Rebuttal Proof of Evidence – Arboriculture Drawings and Appendices

Brislington Meadows, Bristol
PINS Ref. APP/Z0116/W/22/3308537

Brislington Meadows - Review of FLAC Proof of Evidence – Hedgerow Age

CANDIDATE VETERAN TREE HABITAT CONDITION ASSESSMENT SUMMARY

Drawing Number
D7507.43.003.VH11

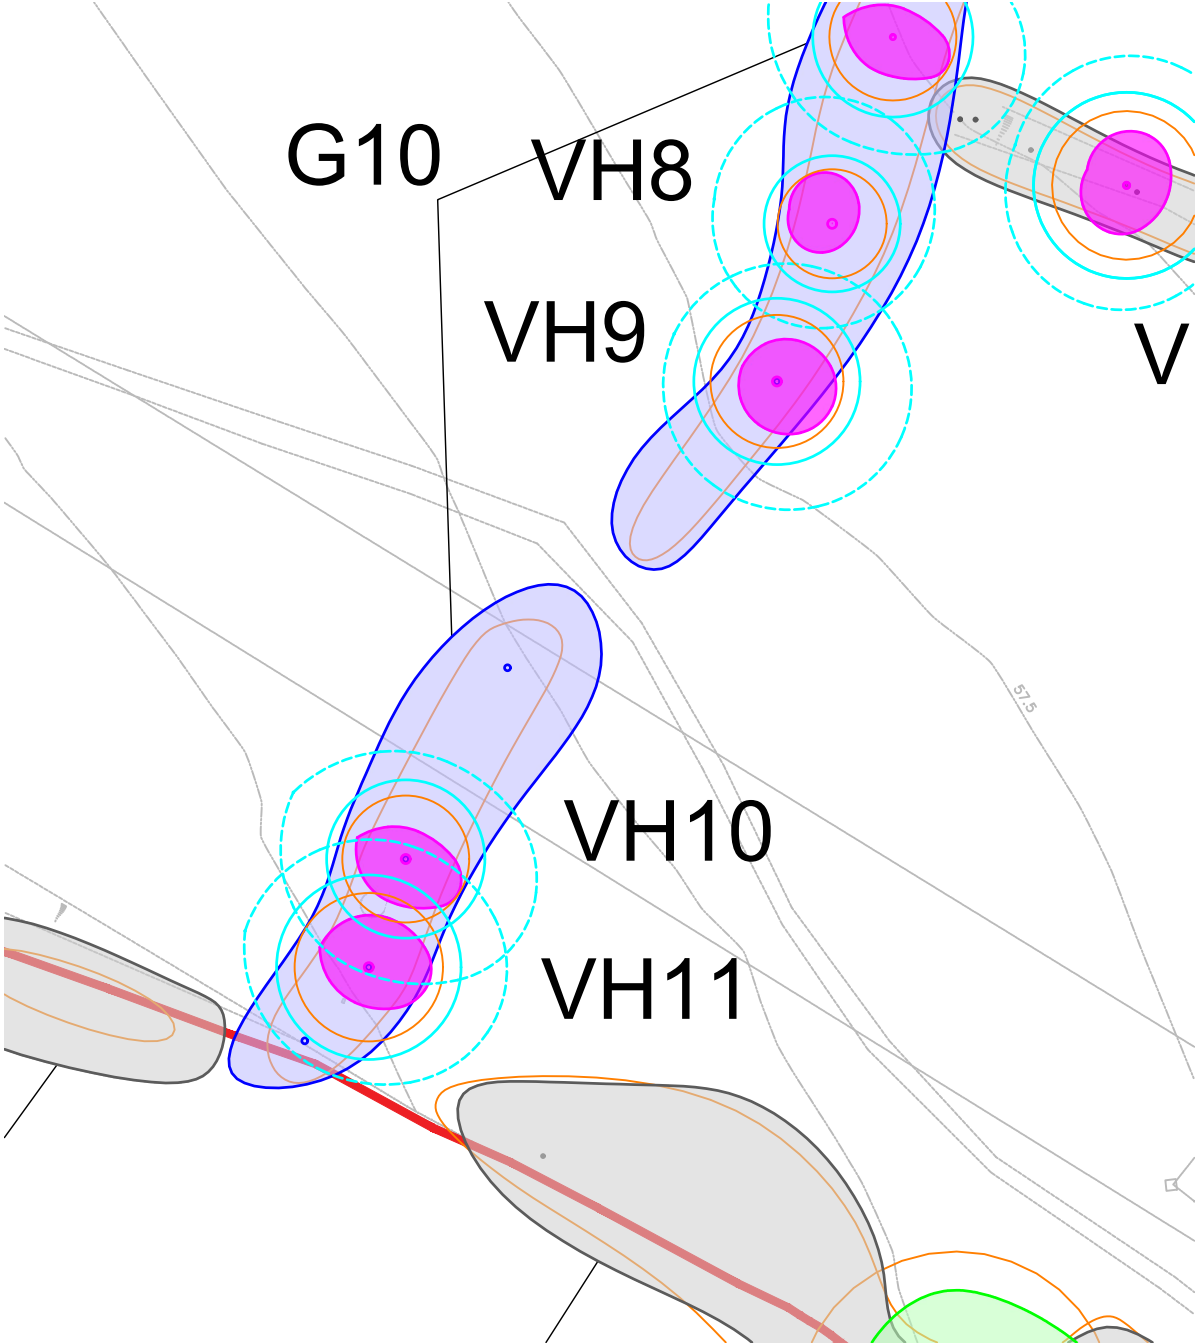
Agreed, in one main stem cavity
- Significant hollowing

Same feature as 'extensive decay' but present.
- Significant retrenchment

Not agreed. Southern tree is significantly in decline, which is not the same as retrenchment.
6. FLAC Claimed 'Secondary Features'
- Lichens present in significant quantities

Not agreed. One branch on northern tree but the rest shaded out by heavy ivy.
